STAFF REPORT: 03-11-20 MEETING
APPLICATION NUMBER: 20-6670
ADDRESS: 441 W. WILLIS AVENUE
HISTORIC DISTRICT: WILLIS-SELDEN
APPLICANT: ROBERT SLATTERY
DATE OF COMPLETE APPLICATION: 02-25-2020
DATE OF STAFF SITE VISIT: 02-28-2020

SCOPE: ERECT NEW THREE-STORY BUILDING

SITE PLAN

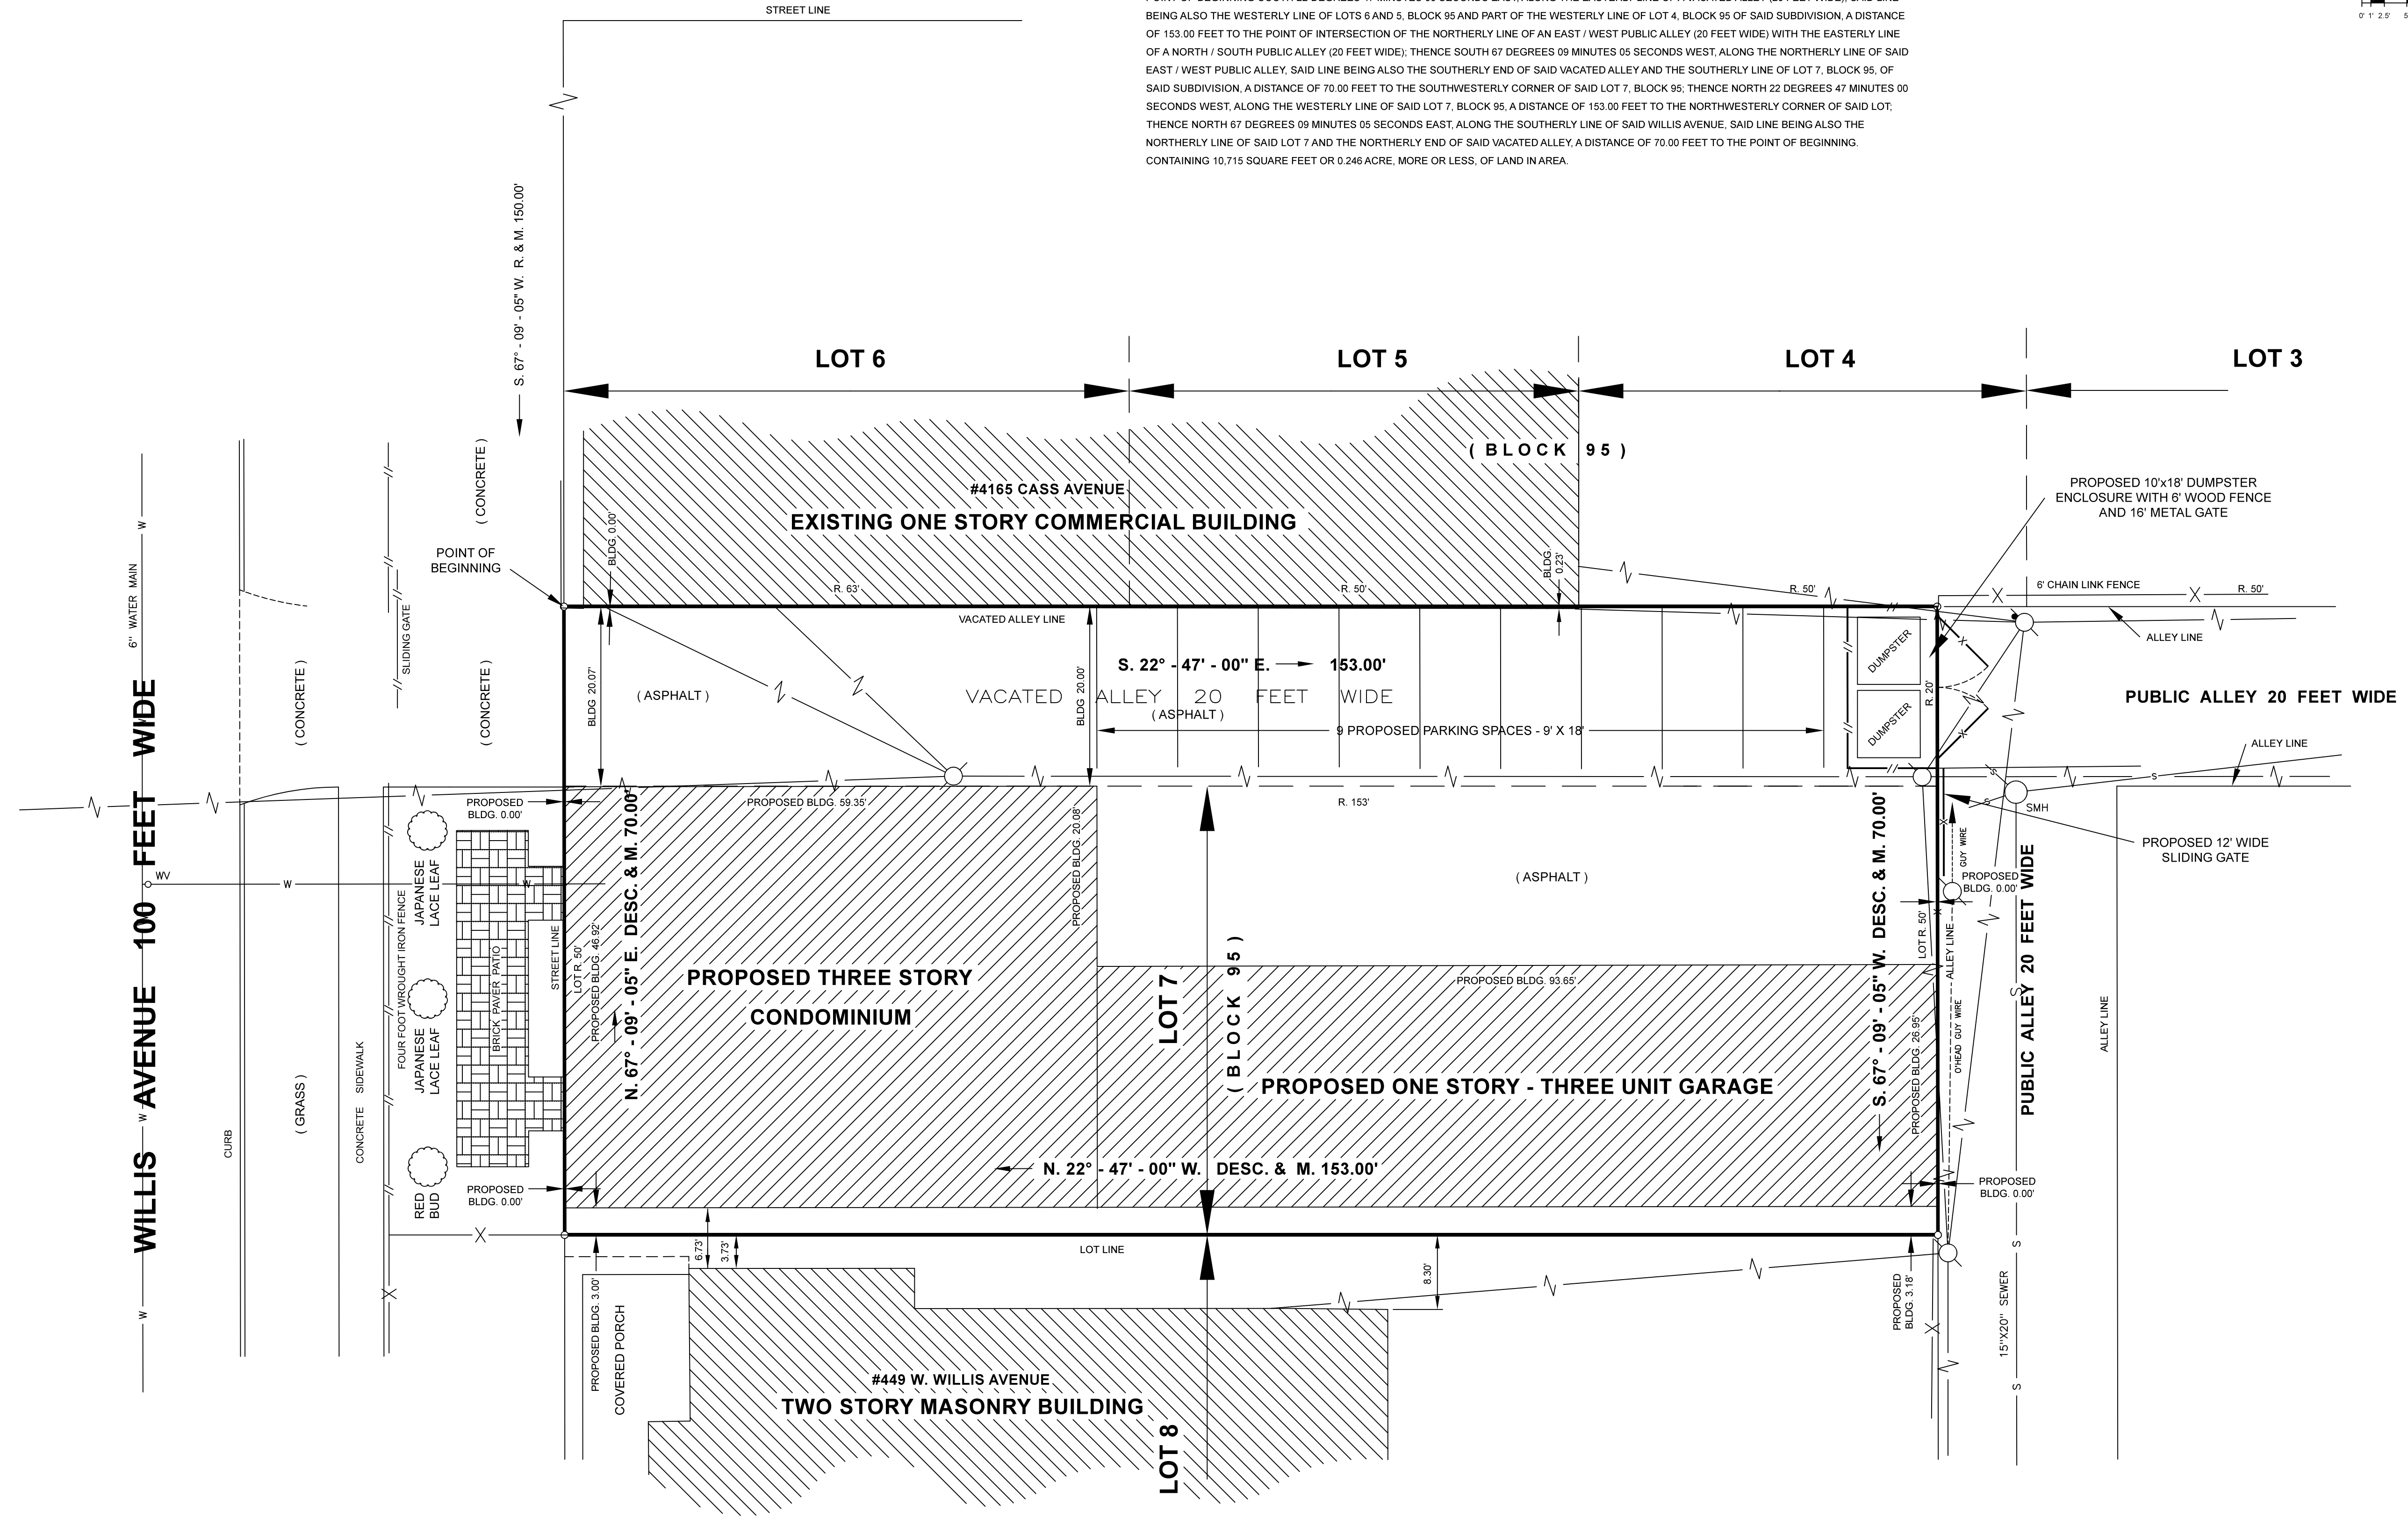
- Dumpster enclosure – design and finish not submitted, description states “6’ wood fence, 16’ metal gate.”
- Gate for vehicular traffic at alley/rear parking is not delineated on the site plan, nor were the design details submitted.

The site plan does not show a sliding gate at the alley at the southern end of the lot, nor any specification on the material, design and height of the gate and fence that would enclose the parking from the alley.

- The site plan, elevation drawings, associated construction drawings (not submitted at time of the staff report) and catalog cuts be revised to reflect all of the details and designs proposed for the project and submitted for HDC staff review.
- A material sample of the face brick, confirming the exterior finish color, along with the mortar color, shall be submitted to HDC staff for review.
- Should the revised plans deviate from the scope of work presented with this staff report, staff will require the applicant to re-submit the project for HDC review at an upcoming meeting.

SIDE ELEVATION (NORTH-EAST)

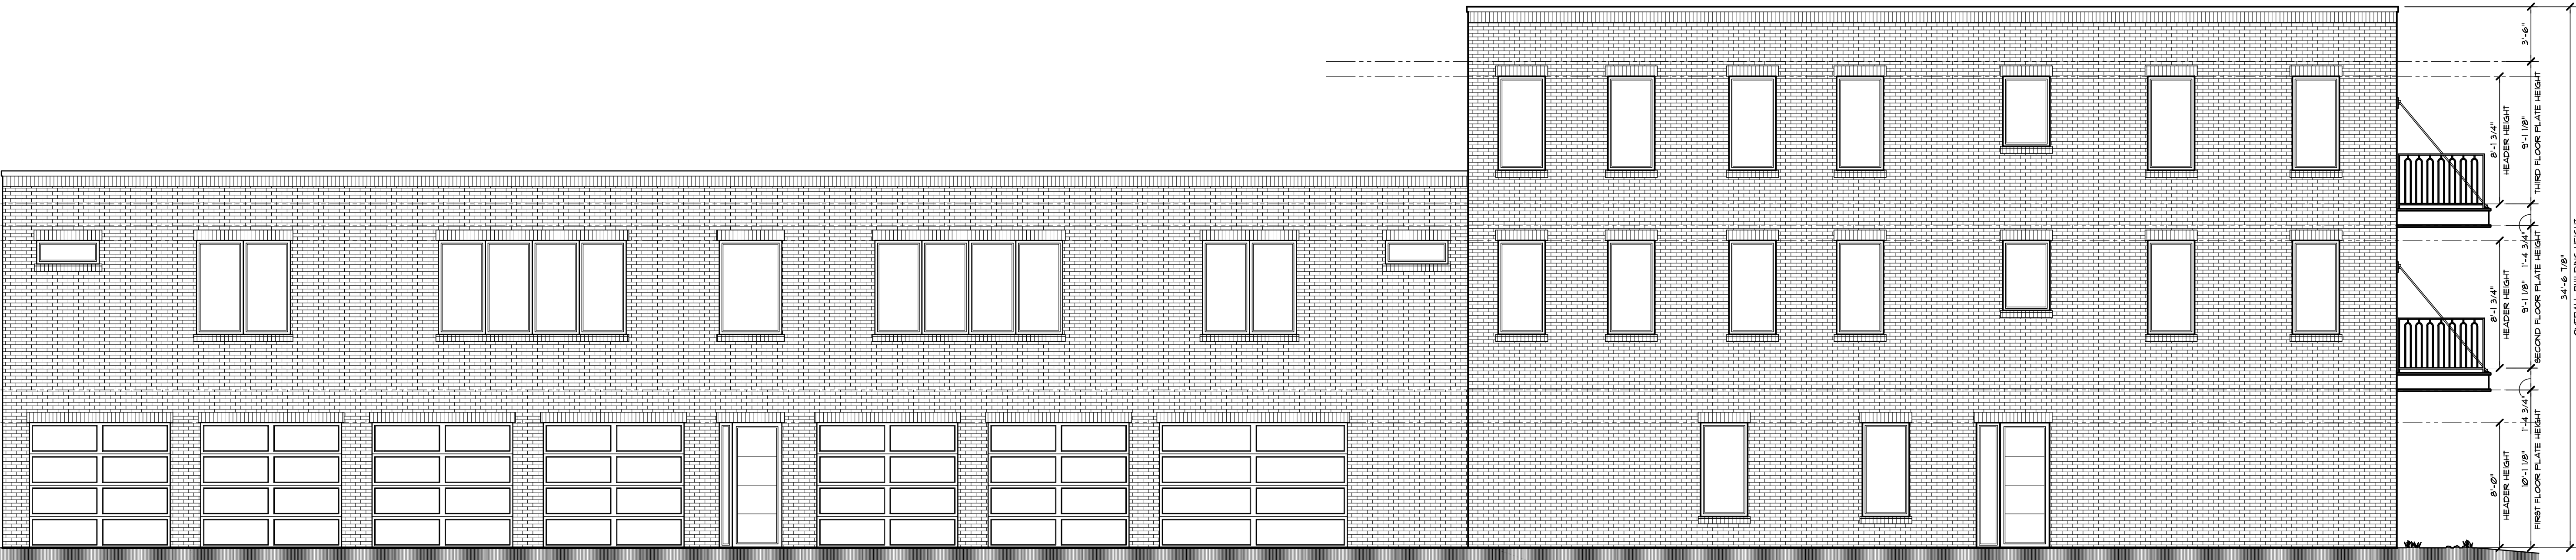
The vacated alley is to remain an asphalt surface for about the first half of the length of the lot; the last half of the alley is proposed as parking spaces (no ADA-accessible space shown). The rendering of the building's east elevation shows an enclosure for a portion of the front surface lot, but it is not shown on the site plan. There also appears to be an entrance door leading to the fenced space, but the east elevation shows two windows where this enclosure is proposed. Additionally, the fence of the enclosure, as well as the front yard perimeter fence, looks to be about seven feet tall, based on the people added to the perspective. However, the site plan says the front perimeter fence is four-feet tall.

- The fence is shown to be exceptionally tall in the renderings. The applicant should clarify the height, design, and placement for each fence installation.
- As noted in the proposal, there are a number of details which need clarification; some of the omissions impact the design of the building and site and must be included on the final plans submitted for review.
